July 21, 2023

**Re: Third Submission Review – Green Valley Ranch Master Plan Amendment No 2 – Comprehensive Plan Amendment, Zoning Map Amendments and Master Plan Amendment**  
**Application Number:** DA-1662-25  
**Case Numbers:** 2002-1001-00; 2005-2018-01; 2005-2018-02; 2005-7006-02

Dear Ms. Bickmire,  
On behalf of Oakwood Homes and Terracina Design, we have reviewed the comments dated January 23, 2023. The following is a response to comments.

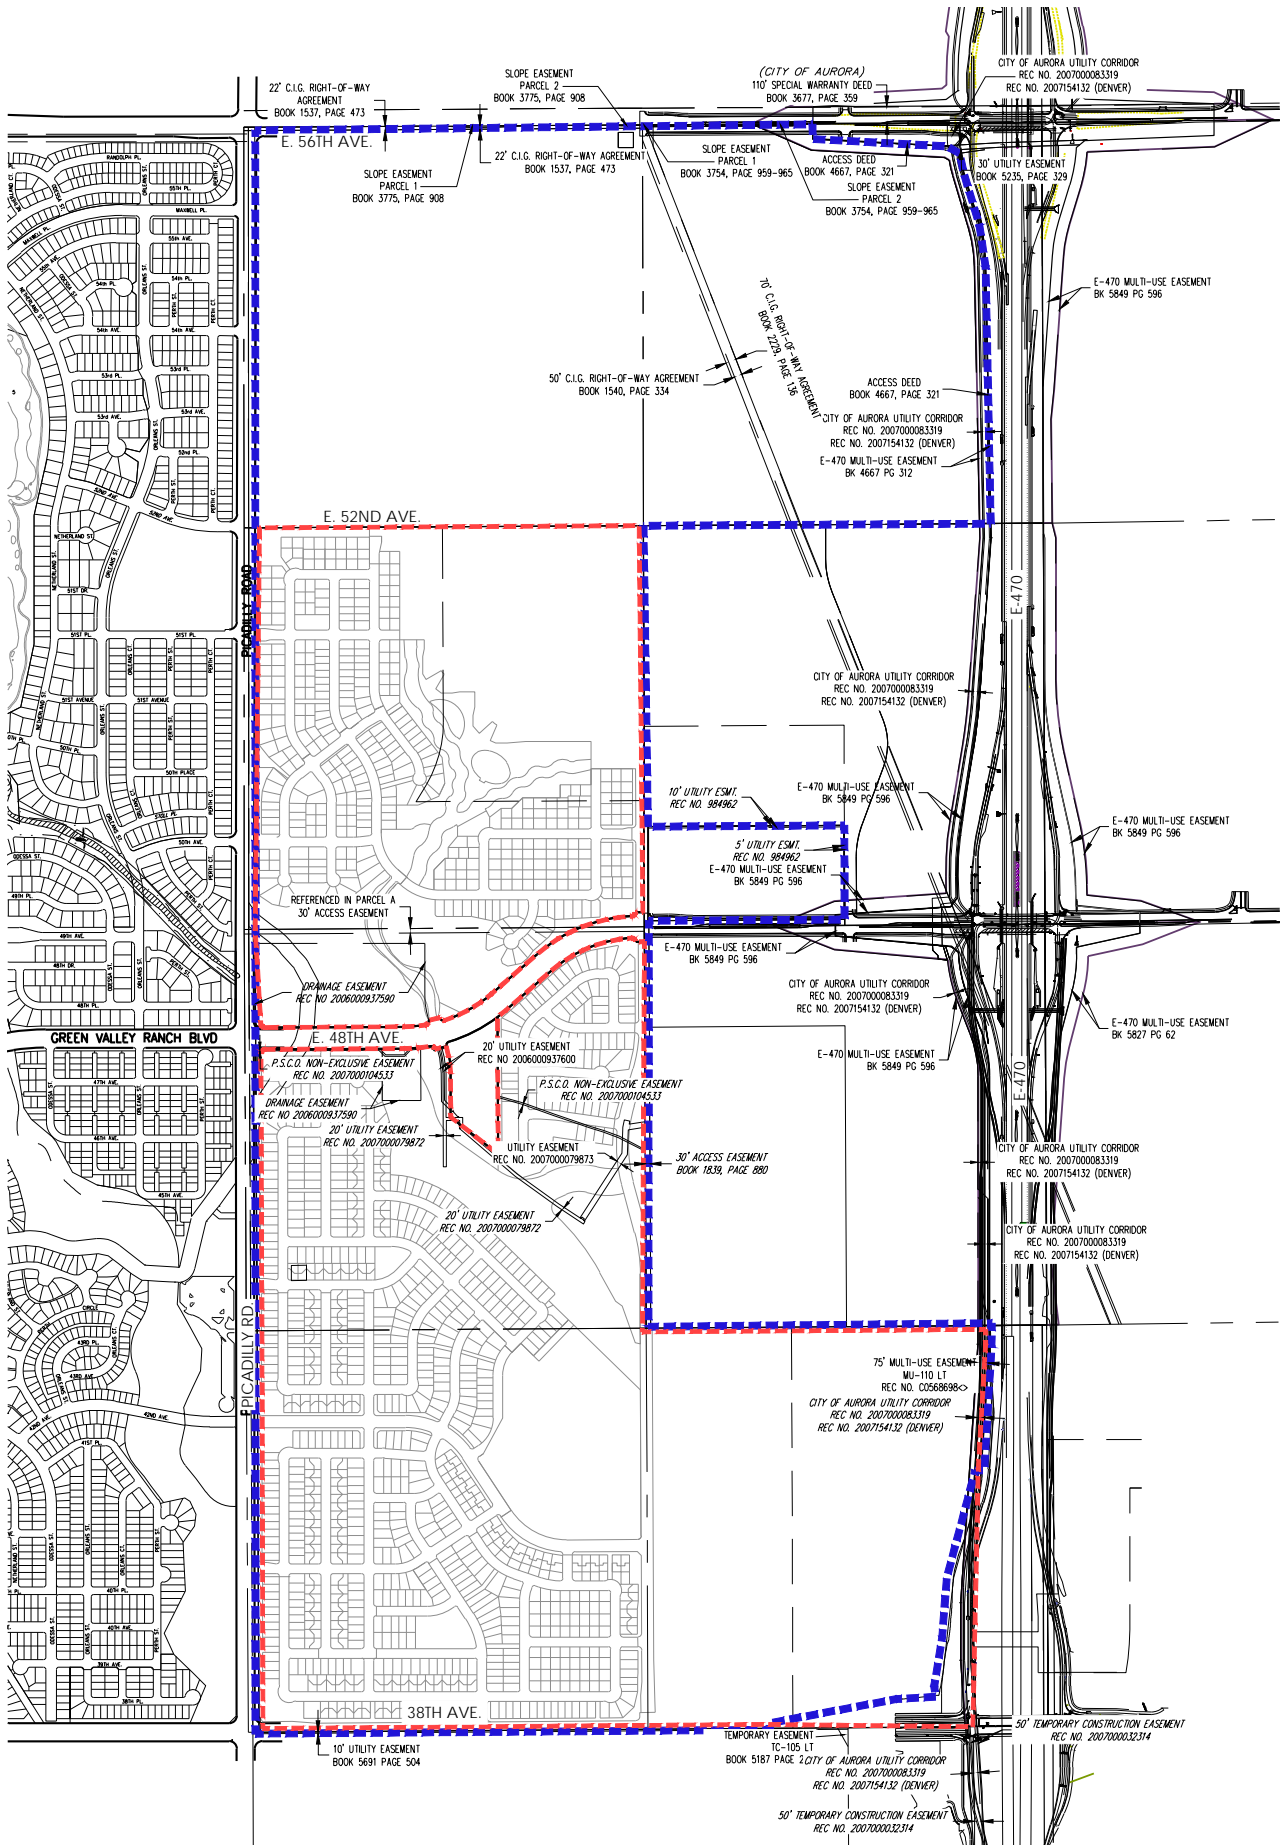
for infrastructure, utilities?  
not sure what this is  
referencing.

# Custom Soil Resource Report Map—Hydrologic Soil Group

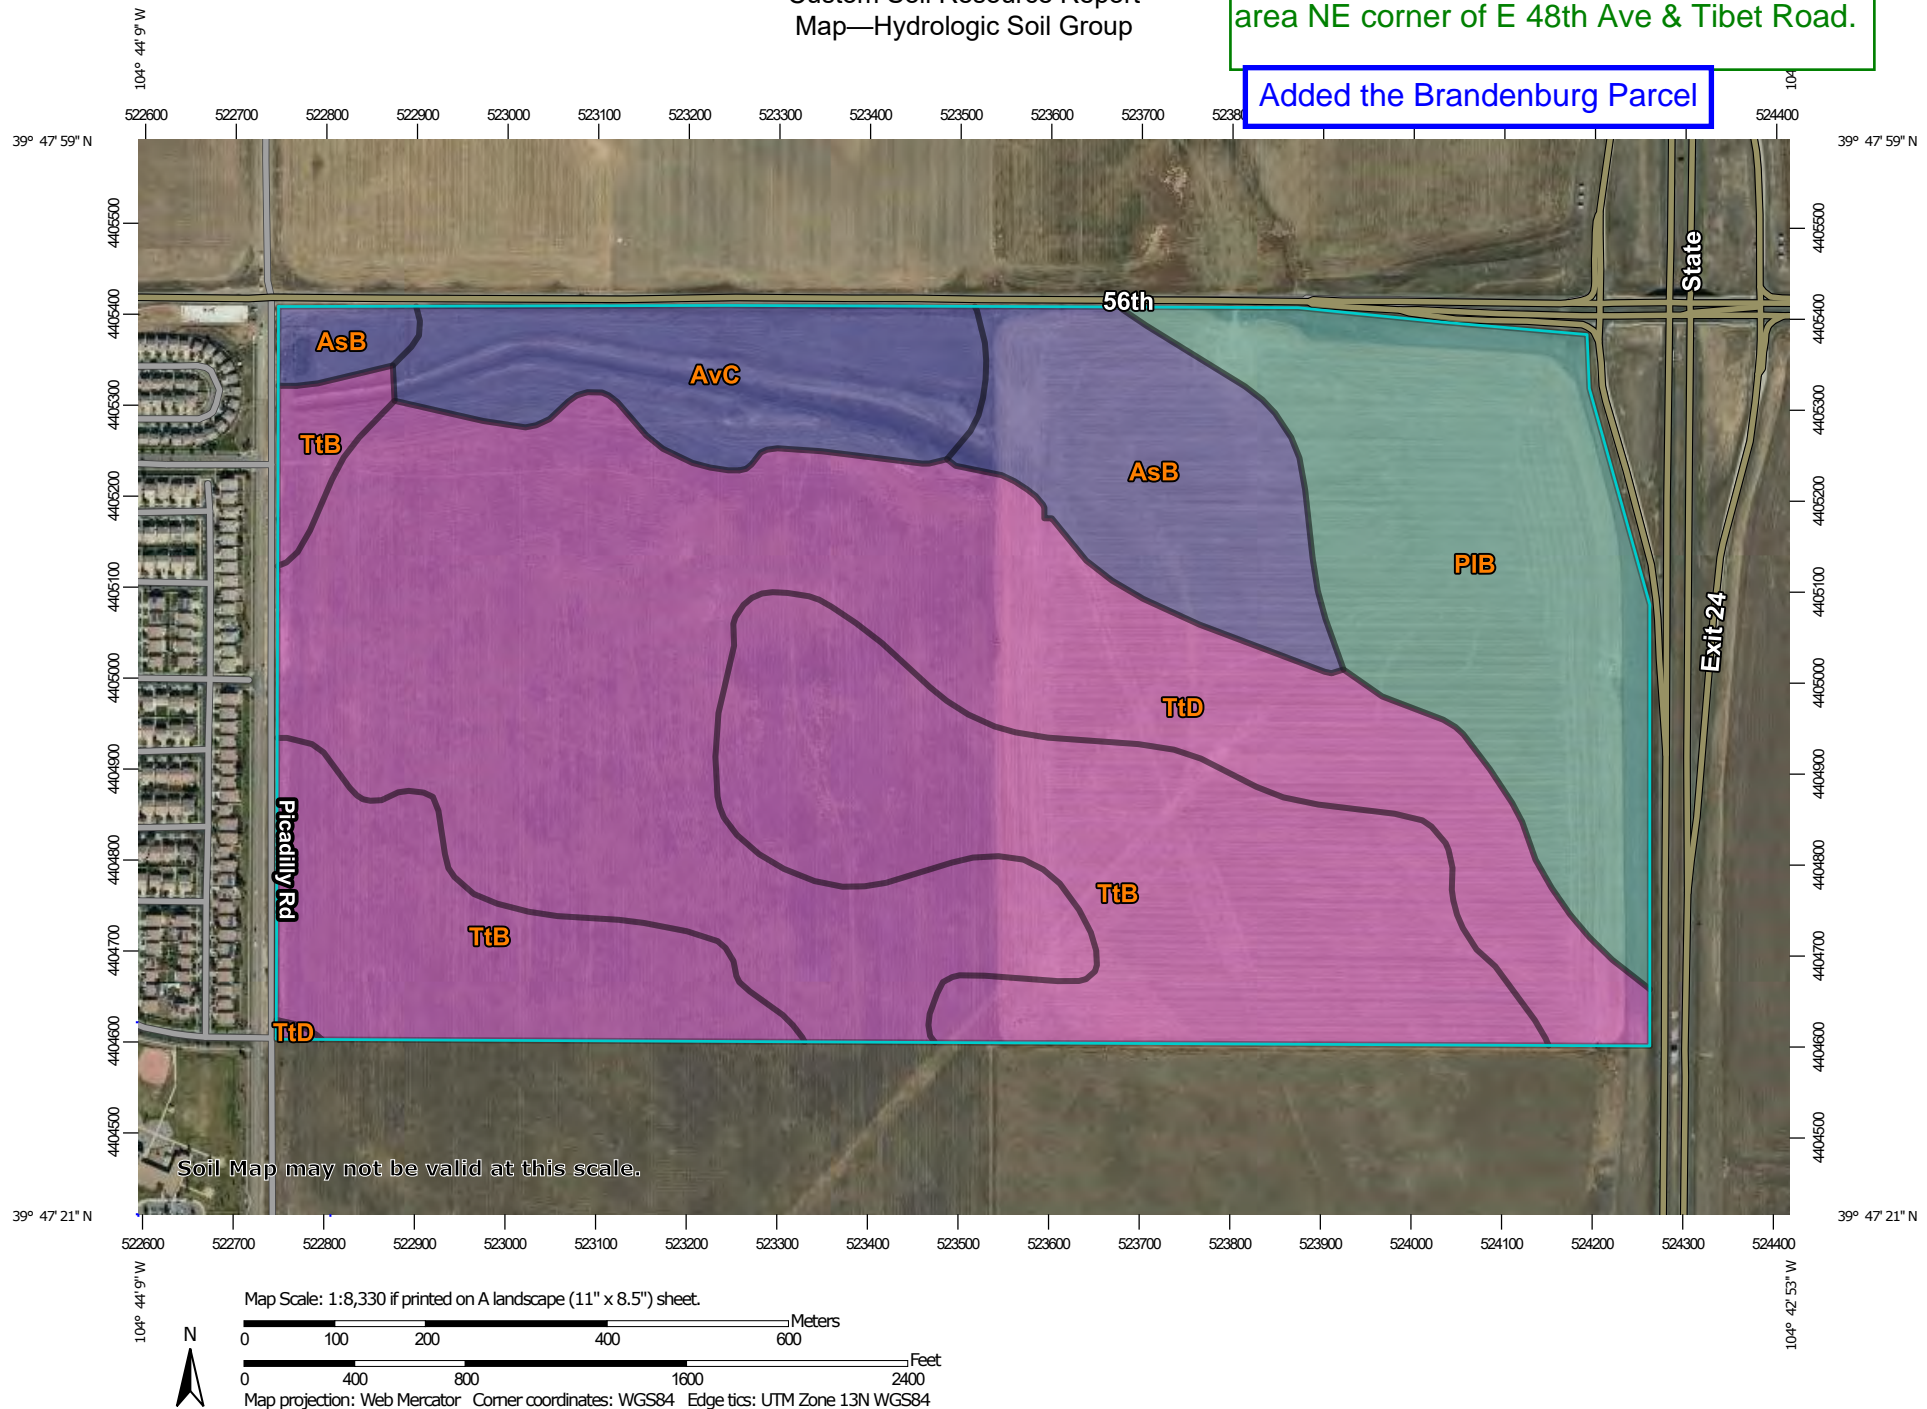
Please also provide the Hydrologic Soil Group analysis for the "south" rectangle area NE corner of E 48th Ave & Tibet Road.

Added the Brandenburg Parcel

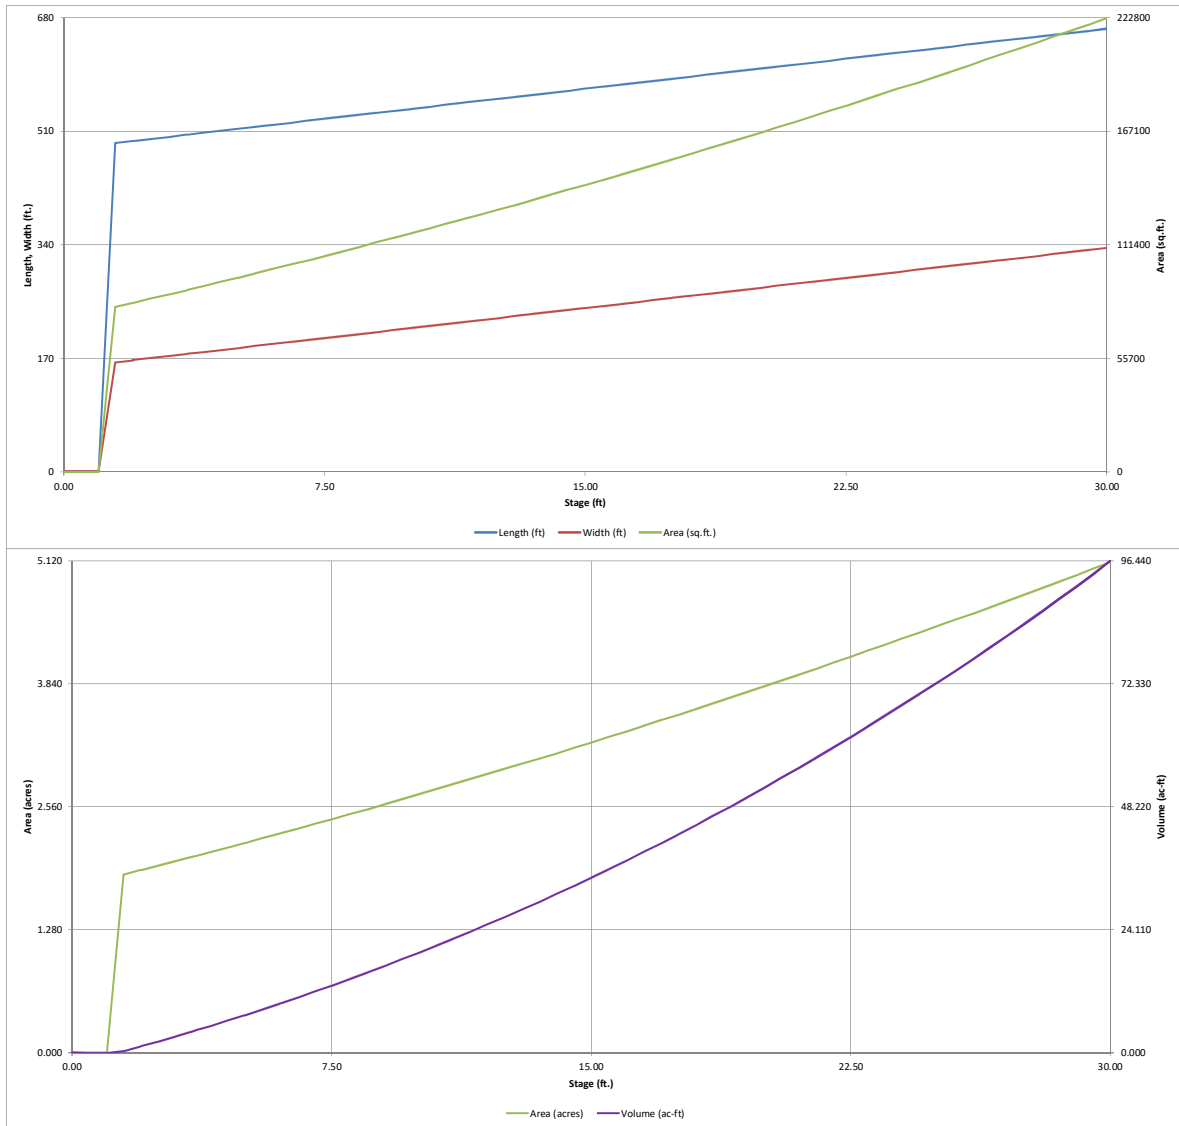
Why is this basin disconnected?

RESPONSE: This basin connects to Trib T offsite with the current conceptual grading
